Technical Basis for Revision of the Pressurized Thermal Shock (PTS) Screening Limit in the PTS Rule (10 CFR 50.61)

Appendices

**U.S. Nuclear Regulatory Commission
Office of Nuclear Regulatory Research
Washington, DC 20555-0001**

Prior to the first peer review meeting detailed information about the developed methodology was provided to the review panel. During December 2003 through February 2004, each of the peer reviewers provided written comments on their subject areas of specialization and also on the overall methodology. These comments and staff response are provided following this page, as comments numbered 1 through 76 (inclusive). These responses were provided to the peer reviewers along with all of the reports detailed in Figure 4.1 that appears in the main body of this report. Following their review of these reports (in general) and the staff's response to their comments (in specific) each of the reviewers provided a letter. These letters appear at the end of this Appendix, along with staff responses (where appropriate).

Figure 1
Cooldown Transients for Palisades

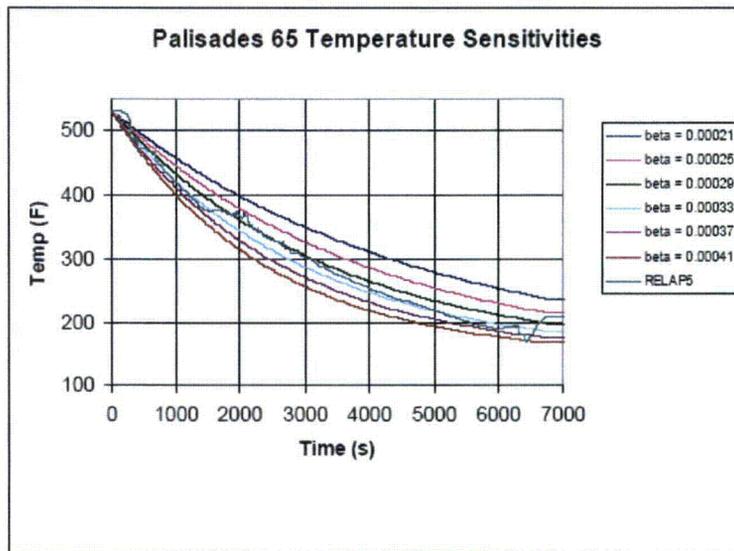
The cooldown rates examined are shown in Fig. 1, taken from the thermal-hydraulic sensitivity study by Bessette. The RELAP5 result was used as a basis and higher and lower values of the decay rate were obtained by using higher and lower values of b . This is a reasonable approach if the initial value calculated by RELAP5 is appropriate. The ranges of values of b chosen, however, yield less than a plus or minus 20% variation in the total downcomer temperature change. The ROSA tests show larger variations than this although it is not clear whether or not the average decay rate is higher or lower. Further, it is not clear how the figure was used; e.g., the given temperature time behavior is used for all the transients. This temperature range needs to be justified and how it is used needs to be explained.

How it was decided that the cooldown rate predicted by RELAP5 is the appropriate starting place is not clear. It seems that this would be a good place to use the results from the OSU testing as it was based on scaled studies. Doing so would give a “code independent” evaluation as well as an opportunity to further validate the code. An initial step might be to incorporate some of the OSU scaling study results (NUREG/CR-6731) into Figure 1.
